WESTPOINTE WEST OFF-SITE SEWER
EXTENSION PHASE 2
SAWS Job No. 18-1674
SAWS Solicitation No. CO-00329

ADDENDUM NO. 2
March 25, 2020

PLAT NO. N/A
 JOB NO. 11581-01
 DATE AUGUST 2018
 DESIGNER RG
 CHECKED RG DRAWN EP
 SHEET C2.00

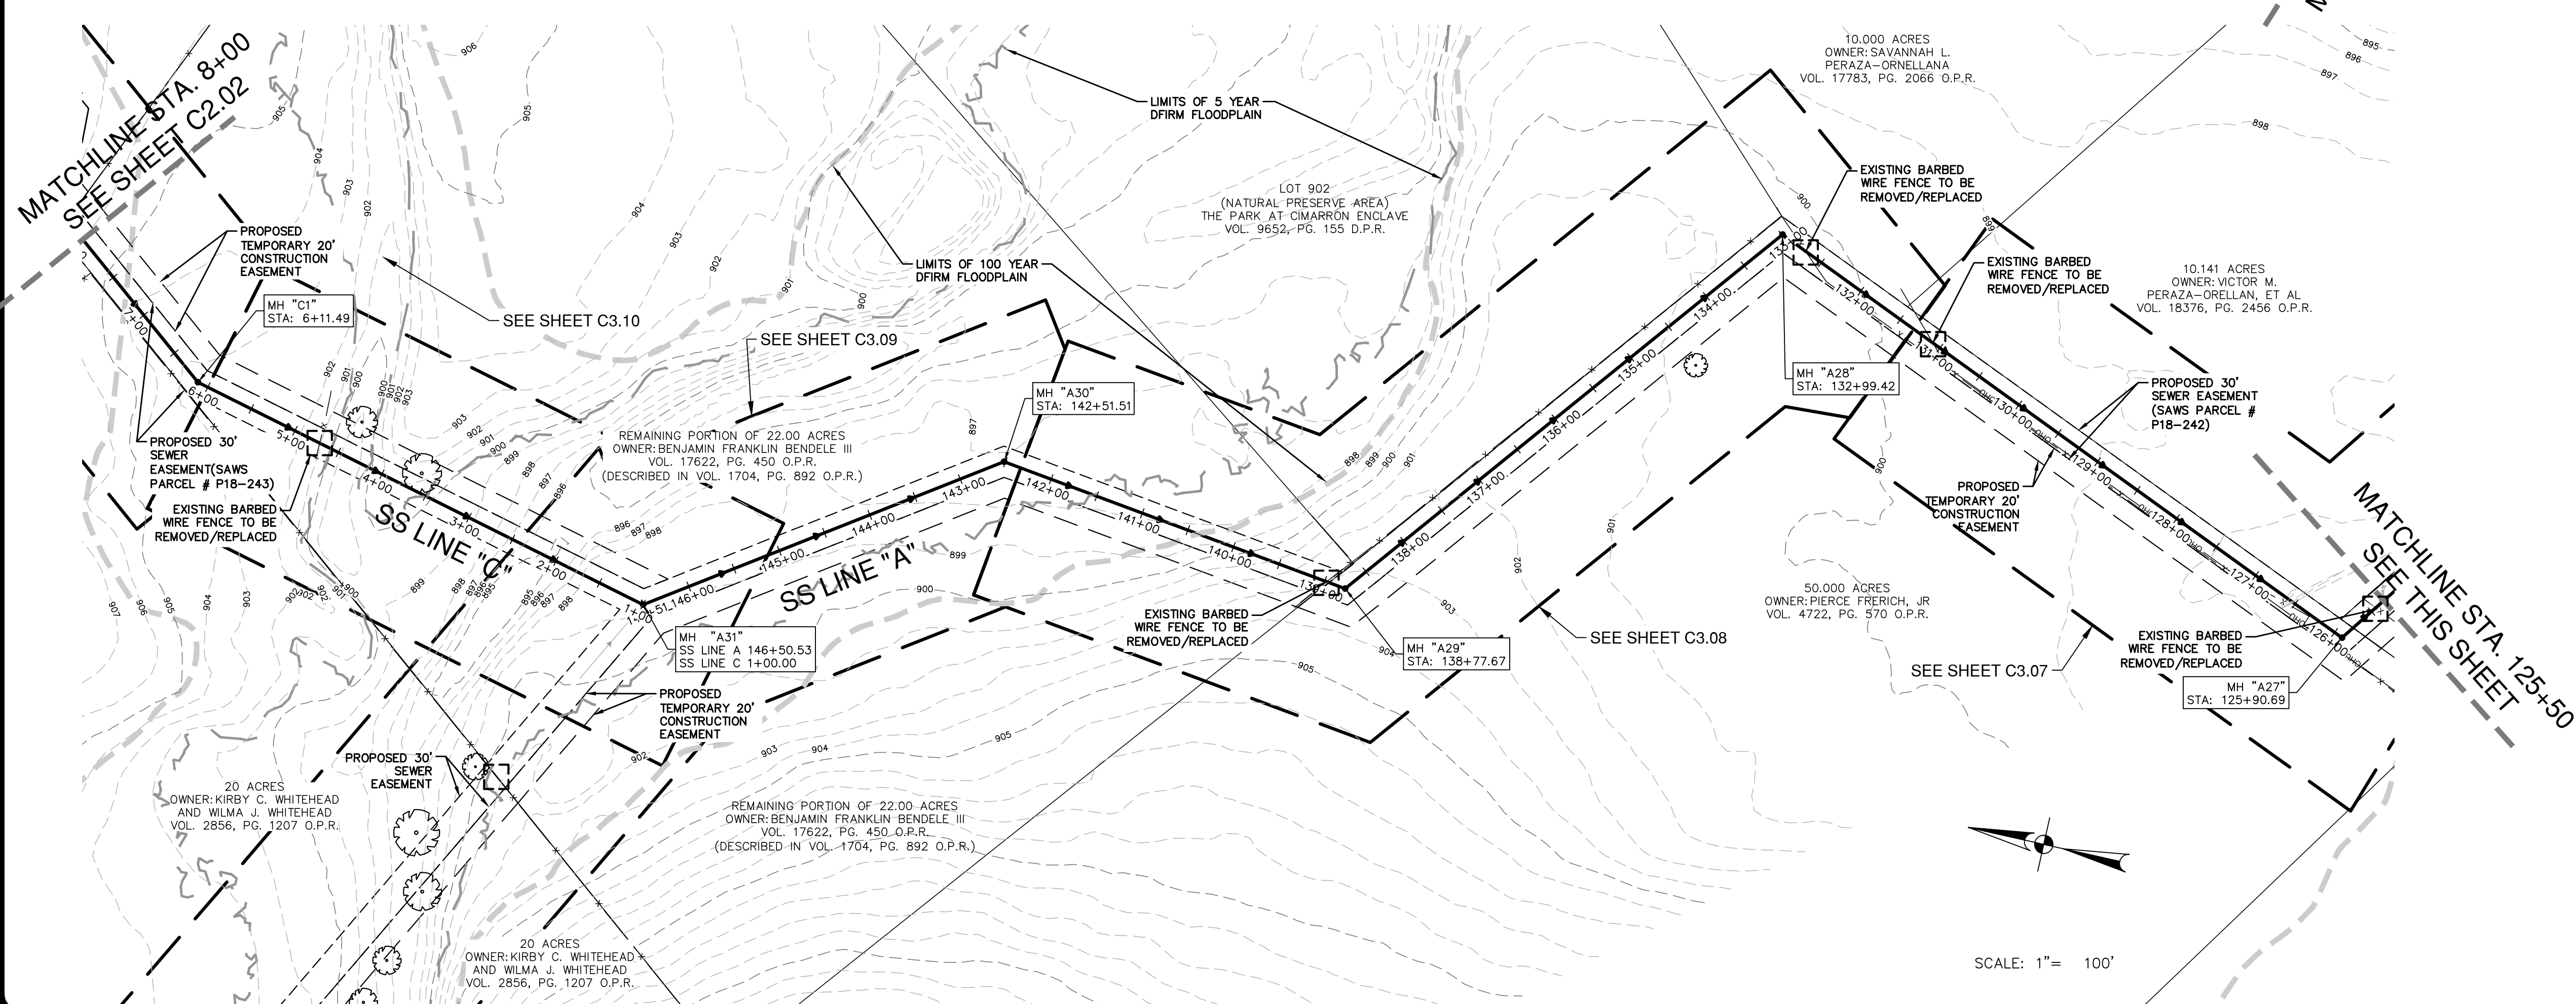
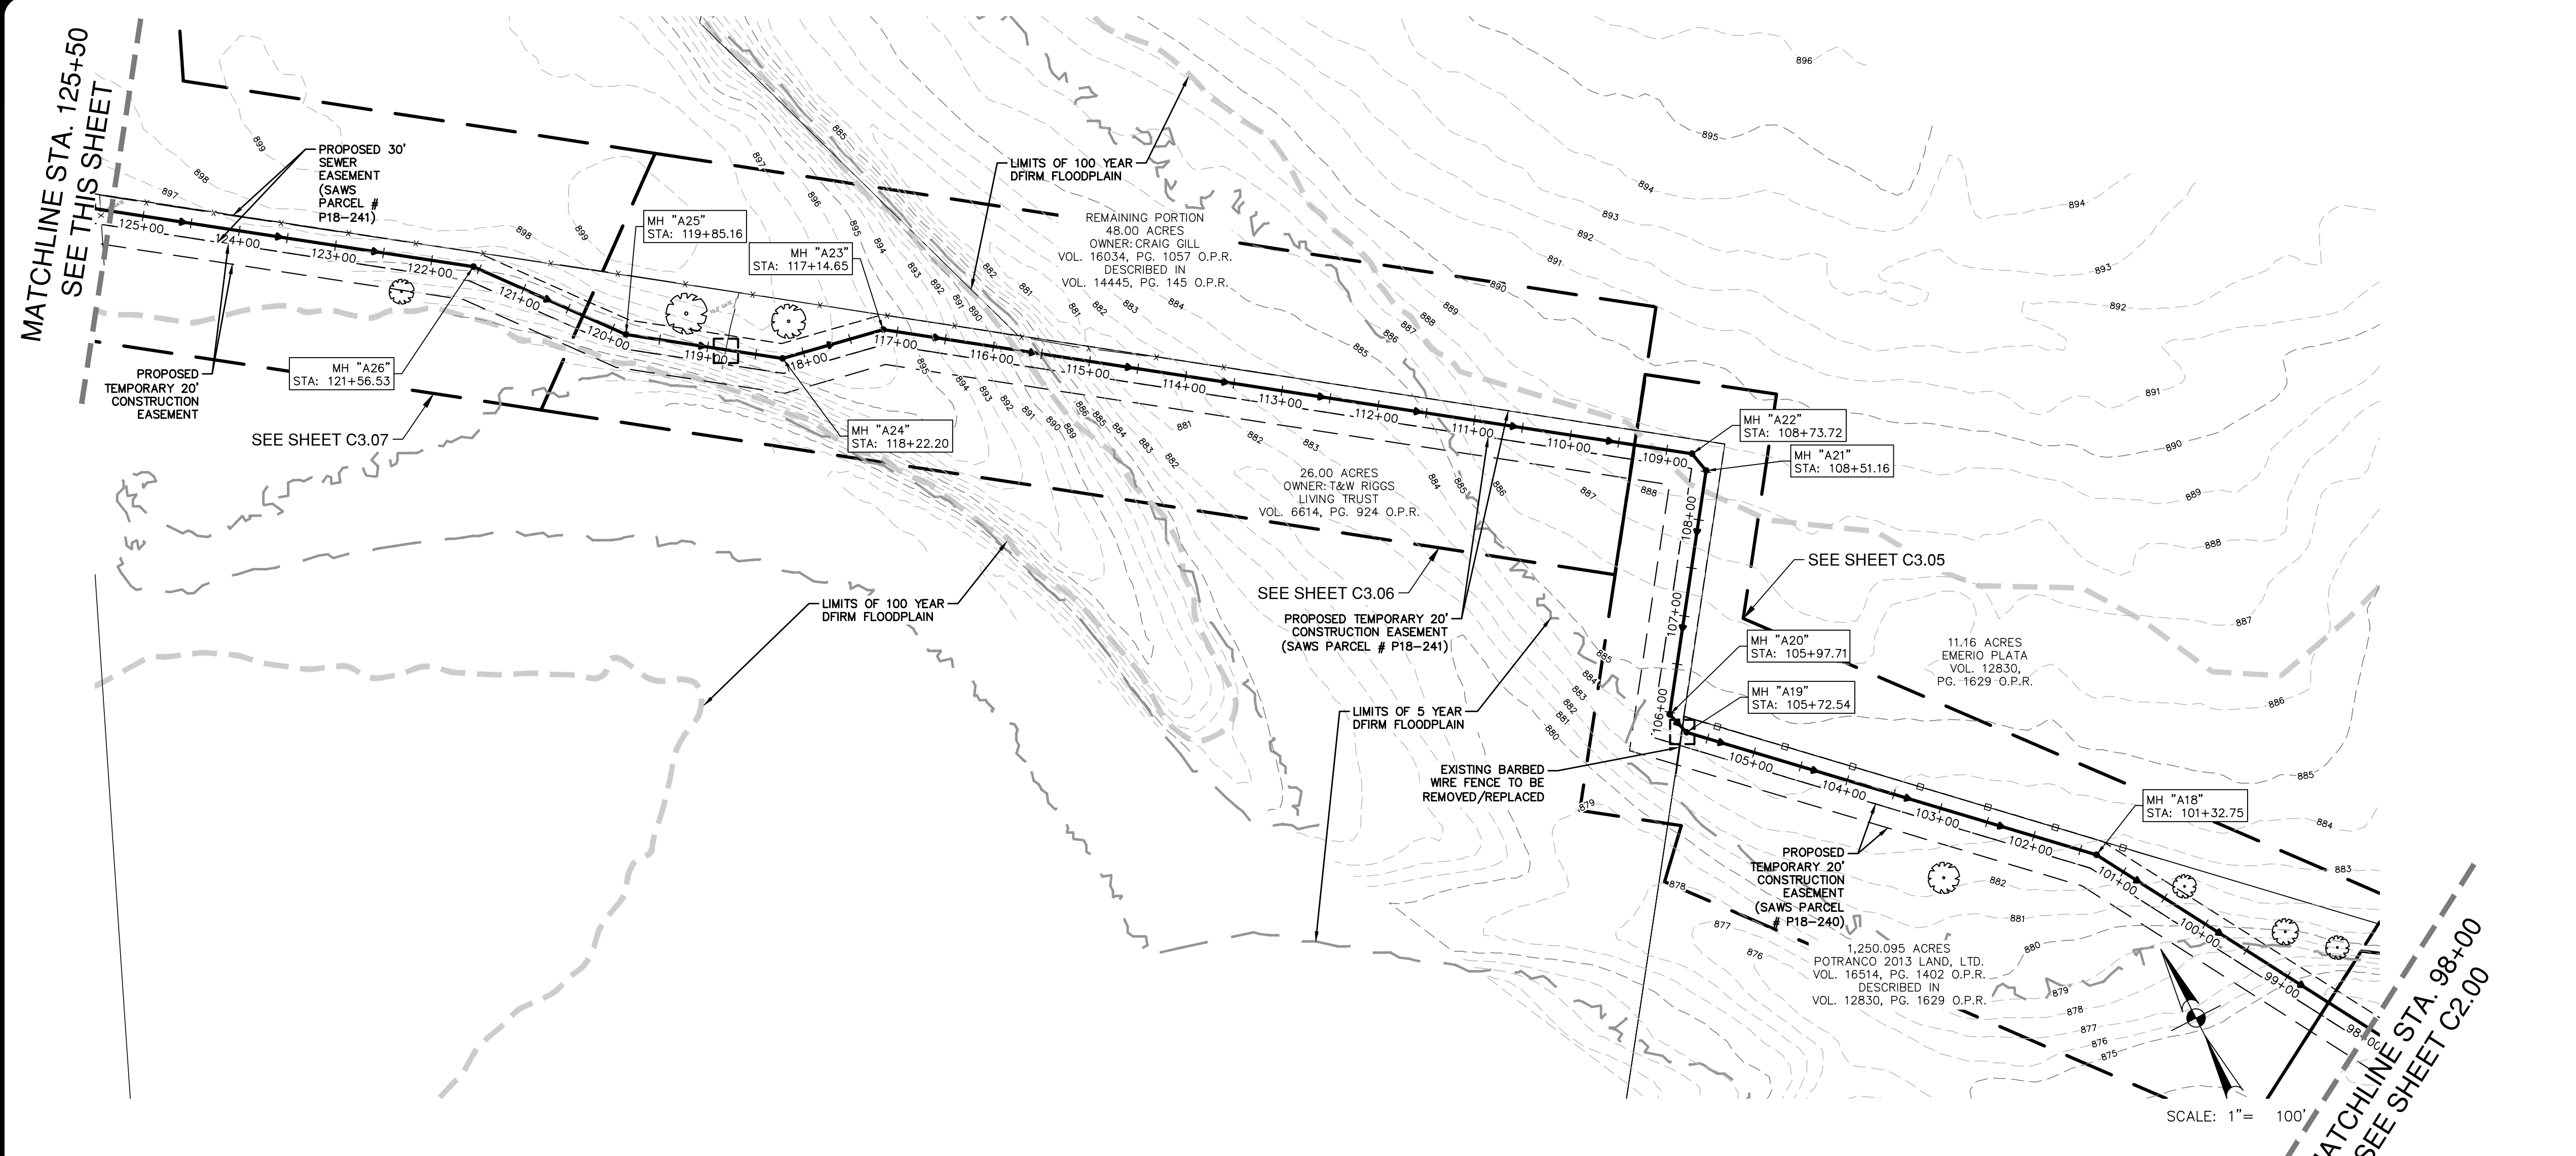
QUESTION 11: Sheets C2.00 and C2.01 do not appear to have plotted correctly from the CAD file. Can you please reissue these two sheets?

RESPONSE: The design team has reviewed the plan sheets and they all appear to have plotted correctly. A copy of Sheets C2.00 and C2.01 are included with this addendum.
